1. Replace Technical Specification Figure 6.2-1 with the attached figure.

# R.E. GINNA NUCLEAR POWER PLANT MANAGEMENT ORGANIZATION CHART

FIGURE 6.2-1

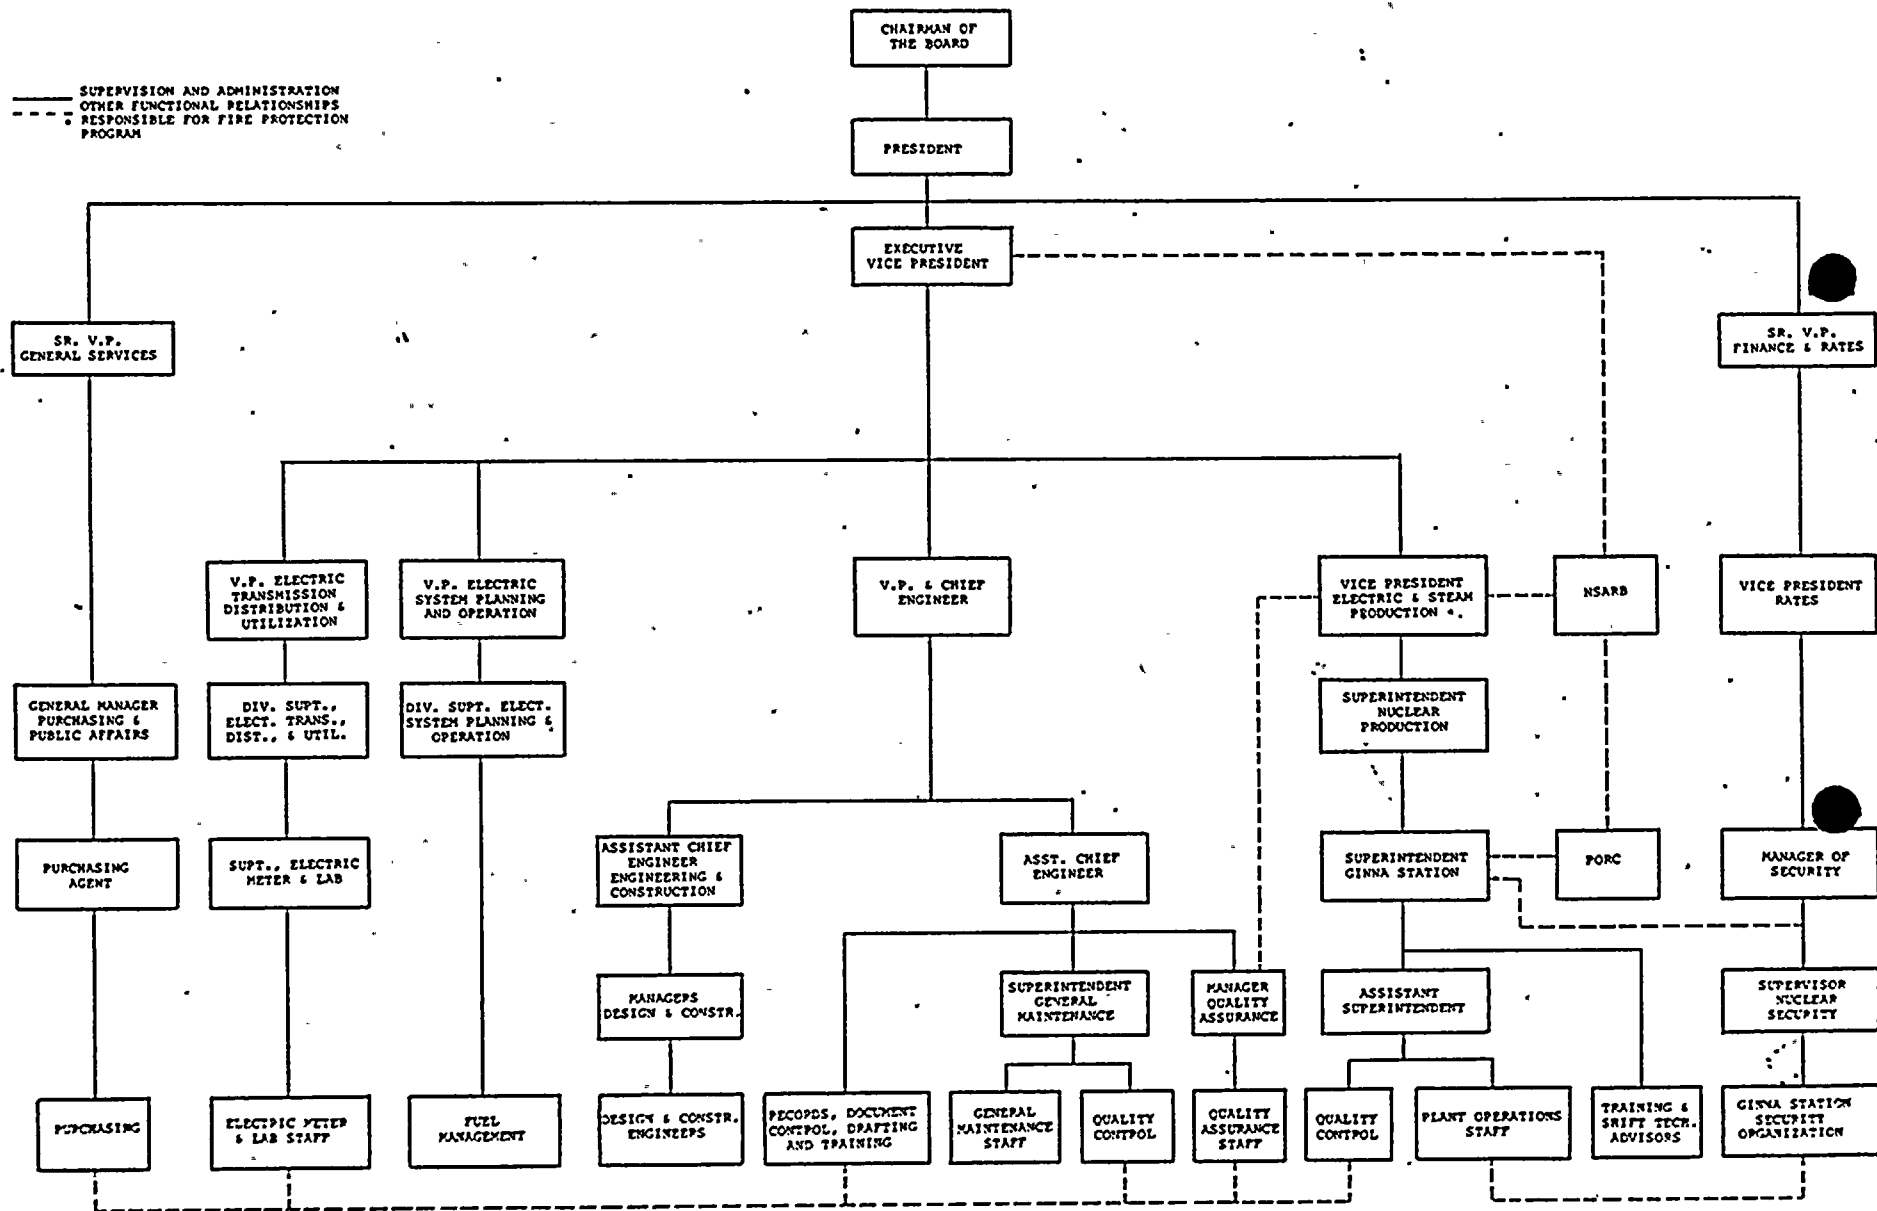
The management organization chart has been revised to reflect recent changes. Two positions of Senior Vice President have been created, Senior Vice President - General Services and Senior Vice President - Finance and Rates. Reporting to the former is the General Manager - Purchasing and Public Affairs. Reporting to the latter is the Vice President - Rates. The position of Chief Engineer has been changed to Vice President and Chief Engineer.
